PLANNING AND DEVELOPMENT SERVICES STAFF REPORT

For Planning Commission Meeting of April 18, 2017

**SUBJECT: 143 Hill Street Planned Project Site Plan for City Council Approval
(139 and 143 Hill Street)
Project No. SP17-001**

CLIENT: MILLER BUILDING LLC
 SITE PLAN LAYOUT

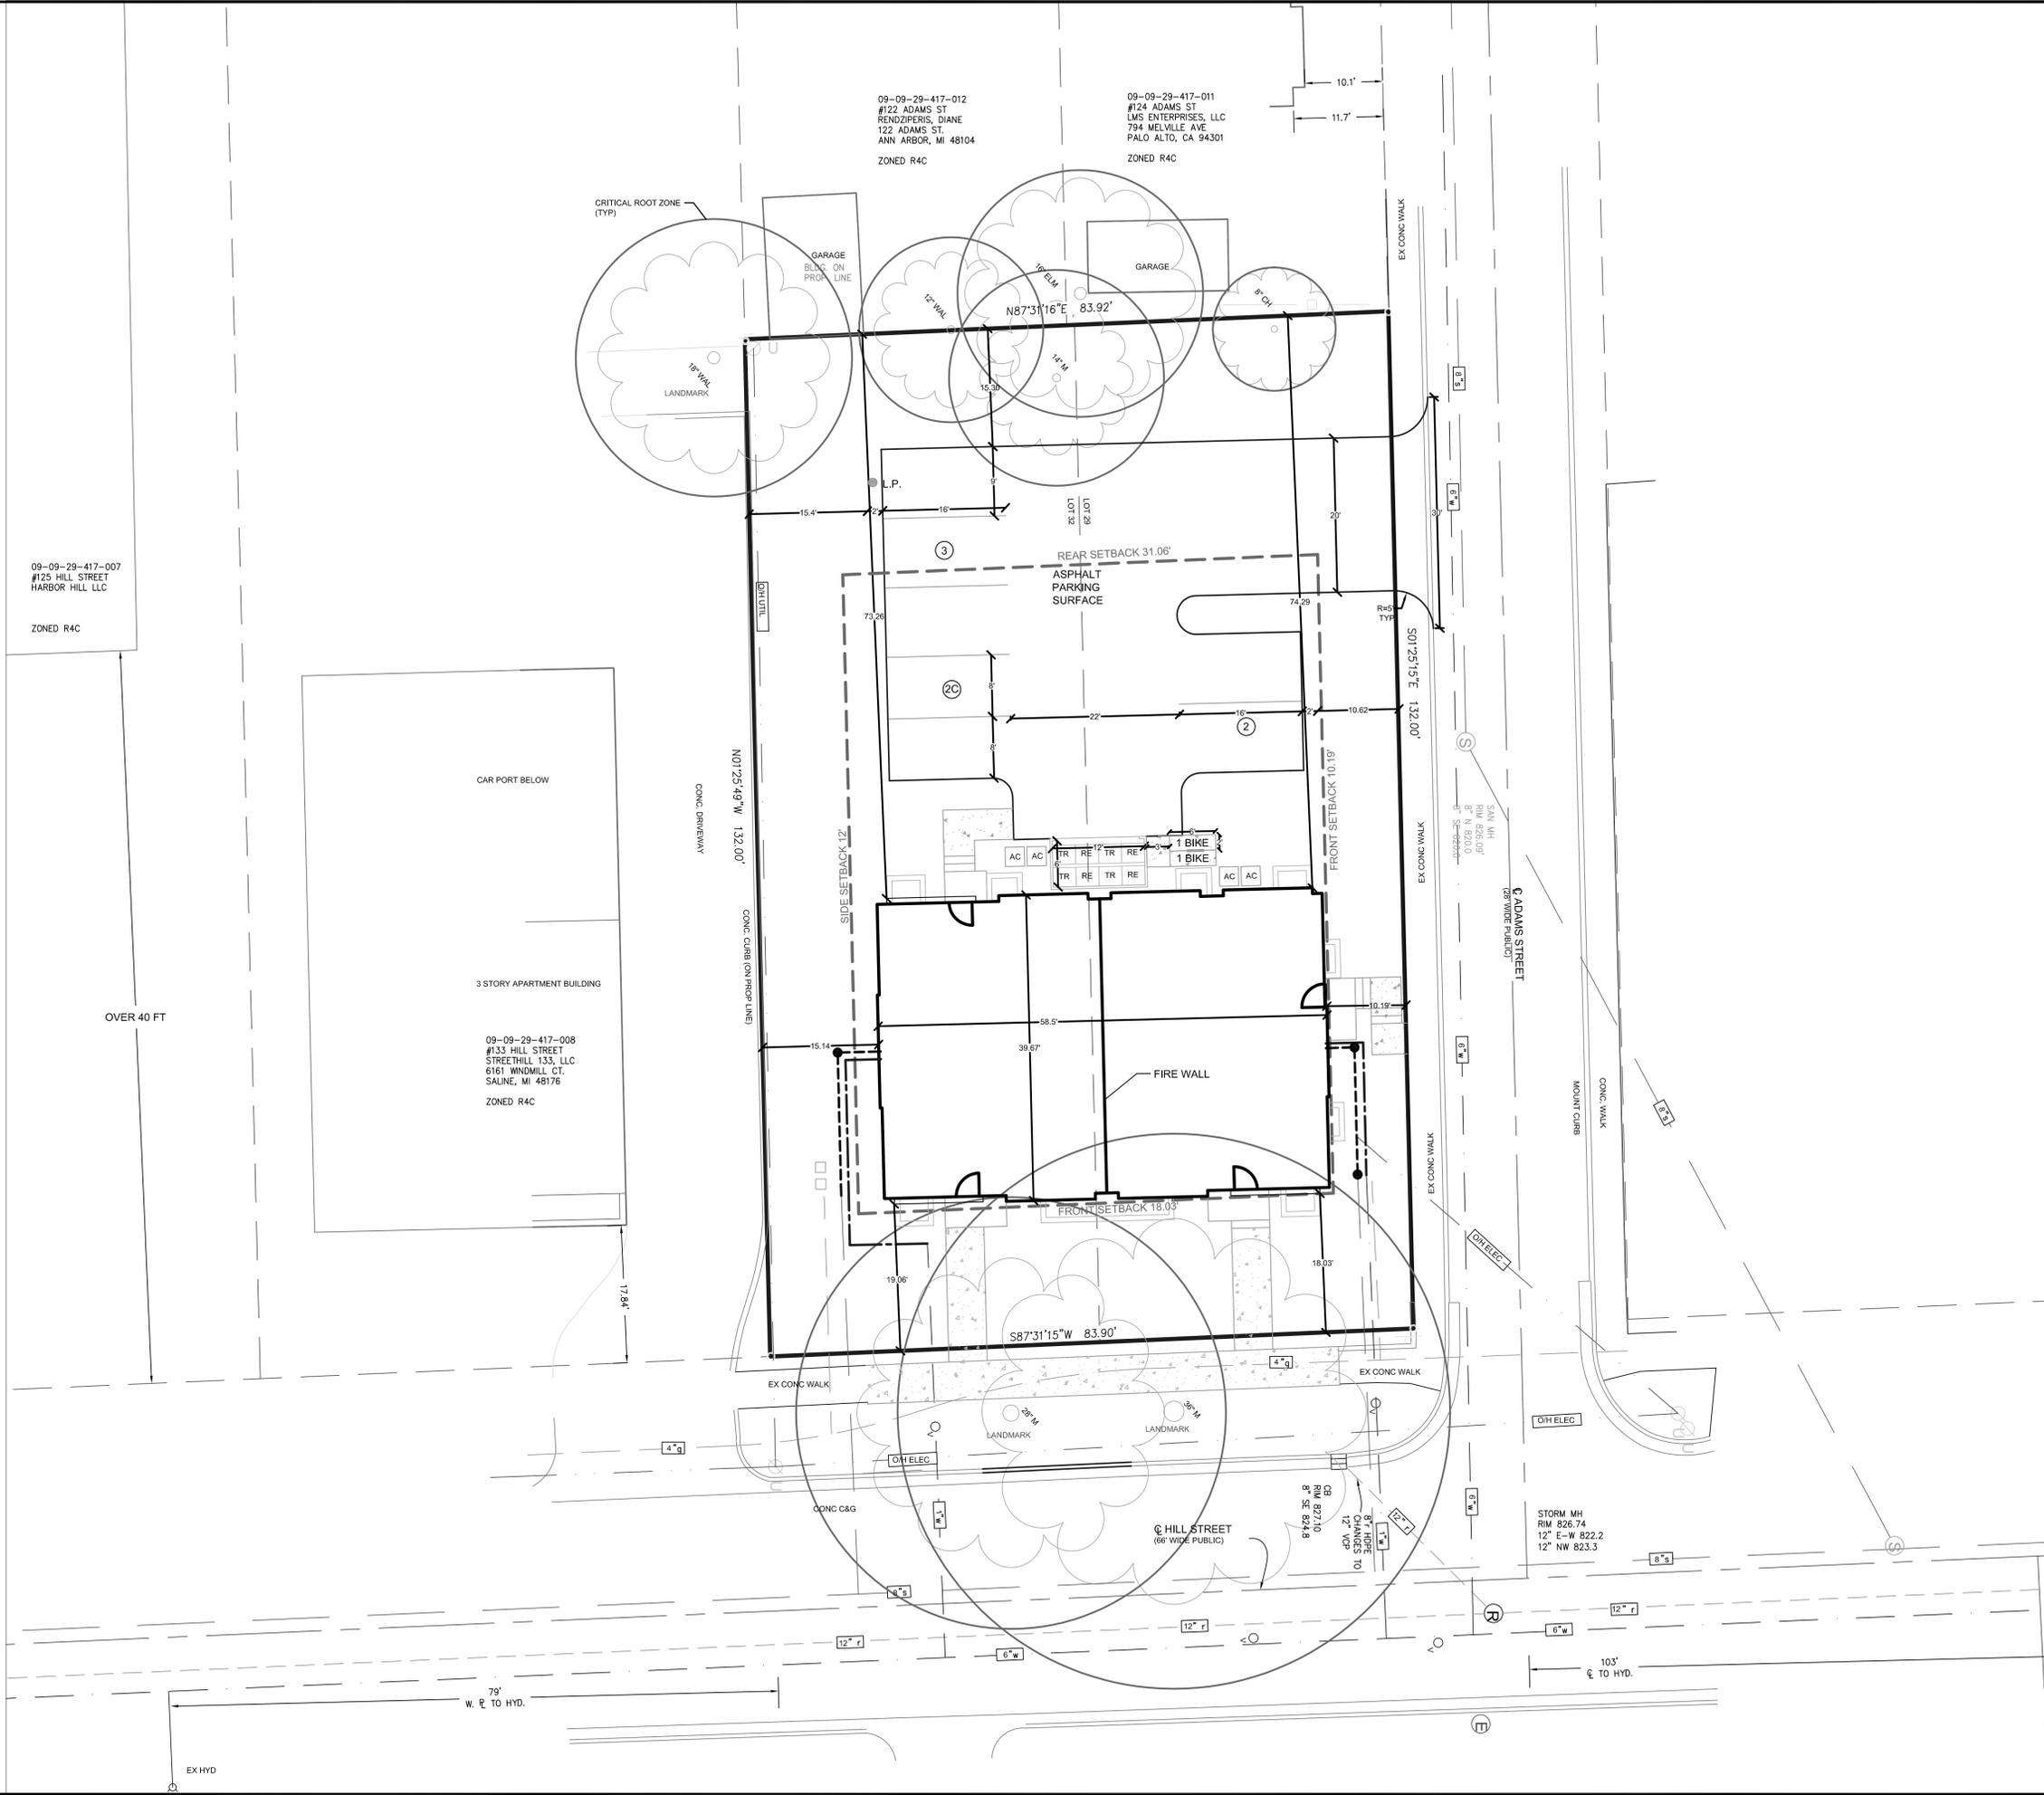
A planned project is requested to modify the Hill Street front setback from the required 29 feet (as averaged) to 18 feet. The benefits of allowing this modification include the provision of a greater amount of usable open space than required by code, and arrangement of the building that provides a public benefit in terms of pedestrian orientation by adhering to the historic setbacks of the site.

SETBACKS:
 ADAMS STREET AVERAGE SETBACK 10.10 FT REQUIRED
 HILL STREET AVERAGE SETBACK 28.92 FT REQUIRED

HILL
 (40 FT+17.84 FT)/2=28.92 FT

The Ann Arbor City Planning Commission hereby recommends that the Mayor and City Council approve the 143 Hill Street Planned Project Site Plan, a planned project with an arrangement of buildings that provides public benefits, subject to a decreased Hill Street front setback of 18 feet and combining the lots prior to issuance of any permits.
